工程指示編號：EI/ 9452 /18

工程名稱： 日出康城 7 期 (平台)

工程項目： WW2 鋁件 顏色 確認 (深灰)

Instruction Nos. CI-MCA-A-051

APPENDIX 2

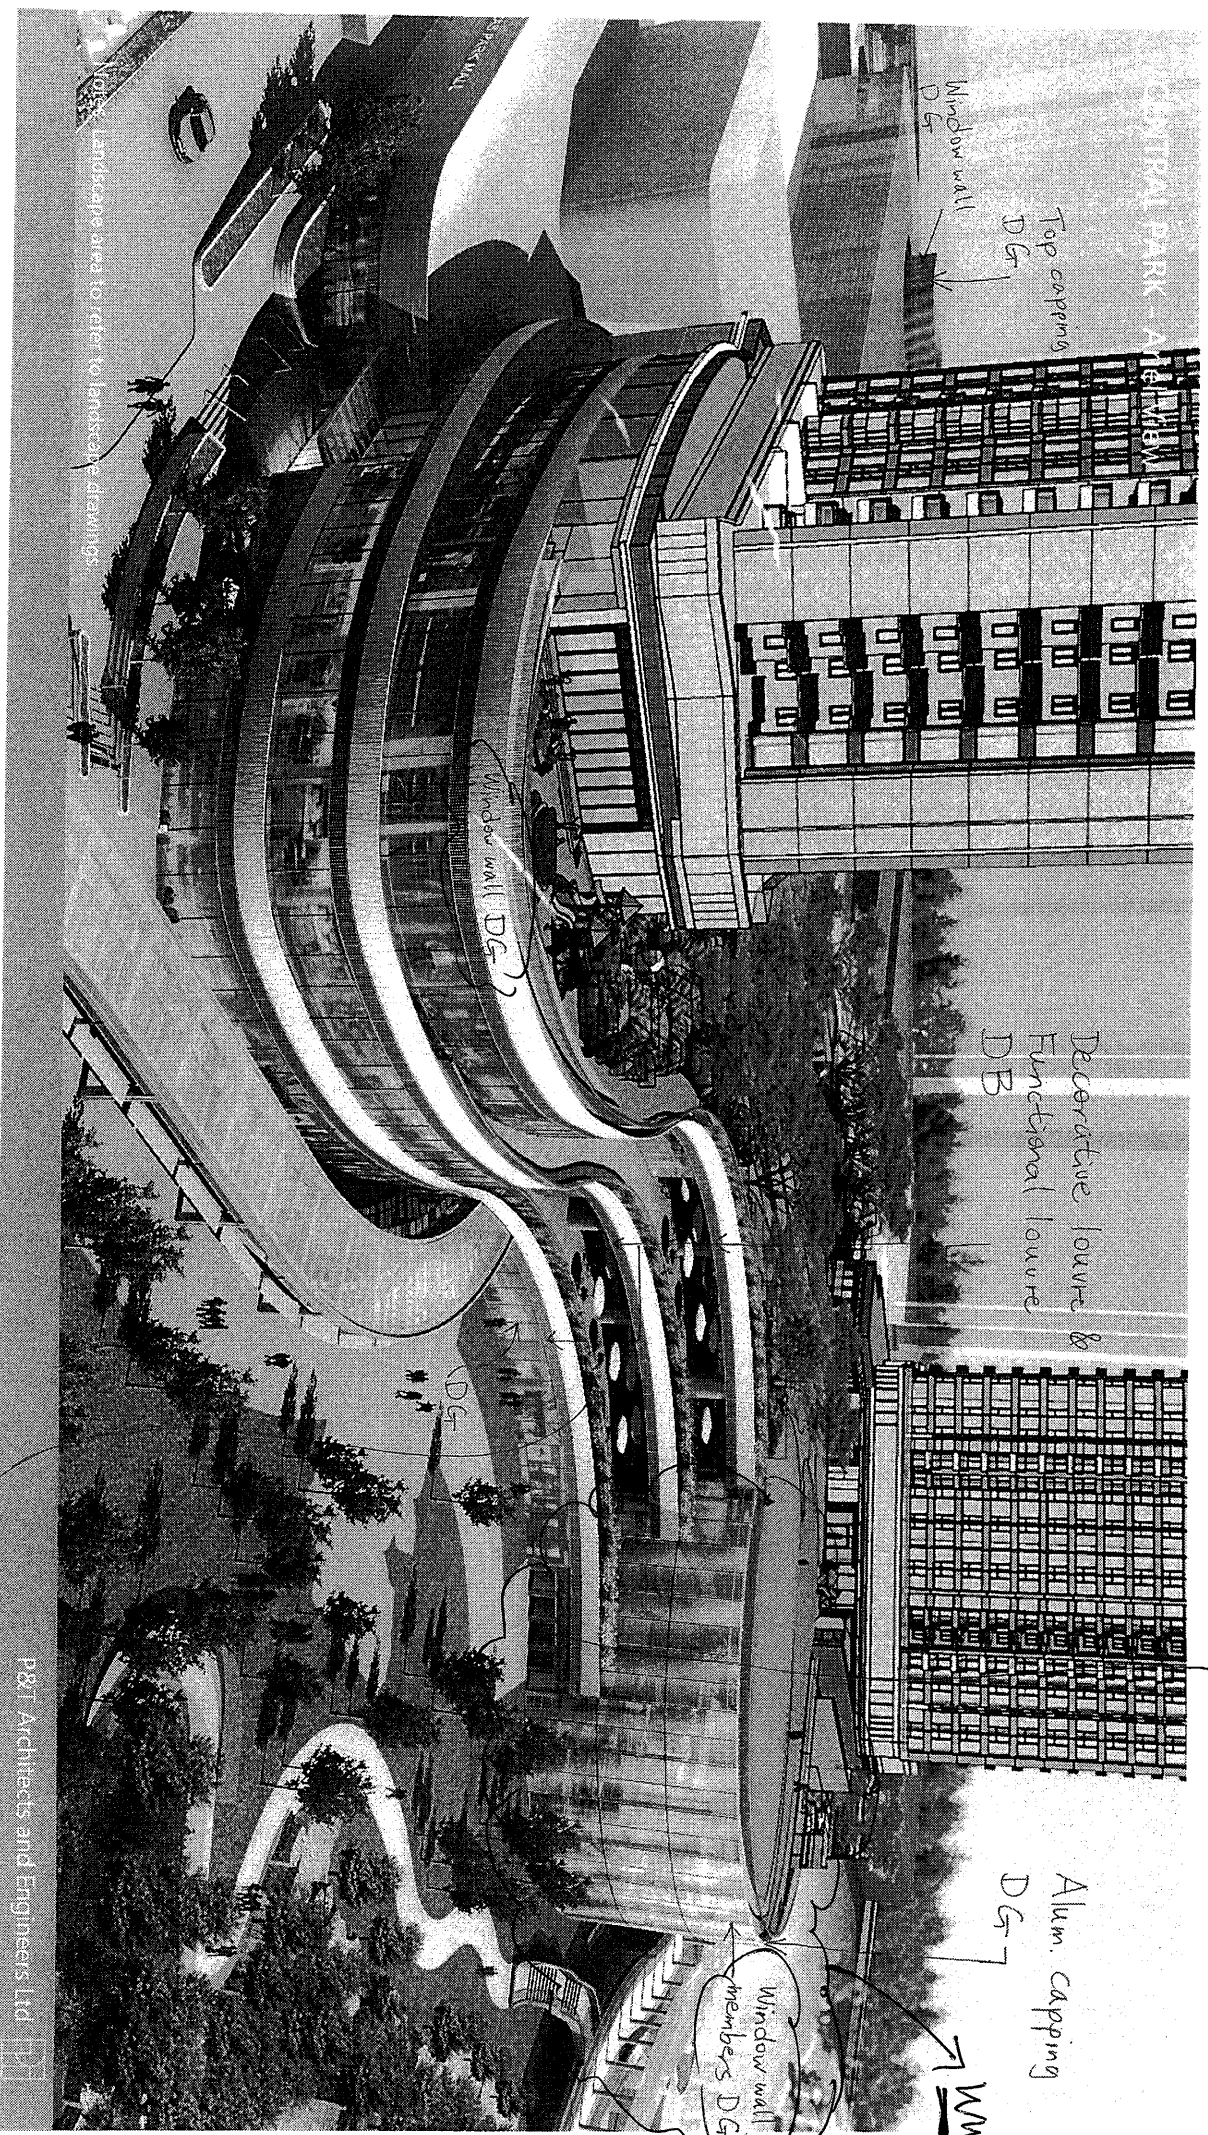
↳ Dark Grey
深灰.

- Samples of colour in aluminium. Please note that GMS in dark grey and aluminium in white (for typhoon proof ceiling) are still outstanding.
 - Series of 3D montage to demonstrate the colour for window wall facades.
 - Section of alfresco dining to demonstrate the colour. Once again to remind COBC to provide updated shop drawing of detail section, to reflect the latest detailing of decorative louvre and stone cladding.
 - Skylights for kindergarten and mall.
- (Same email as Confirmation on the surface finishing color for Window Wall dated on 8th Sep 2018)
- Canopies for WW1, E1, kindergarten and roof.
- (Same email as Confirmation on the surface finishing color for Window Wall dated on 8th Sep 2018)
- Cooling tower façade.
- (Same email as Confirmation on the surface finishing color for Window Wall dated on 10th Sep 2018)
- Sealant colour.

You are also reminded that the change of finished colour on window wall mullion to Dark Grey have been raised in the façade review meeting dated on 20th July 2018.

4.

D.G. = Dark Grey
 D.B. = Dark Bronze
 C.G. = Champagne Gold

Alum. capping for alfresco dining ext. balustrade (C.G.)

Exit BOH door
 S.S. Silver cover

Decorative louvre & Functional louvre (D.B.)

Alum. capping (D.G.)

Window wall members (D.G.)
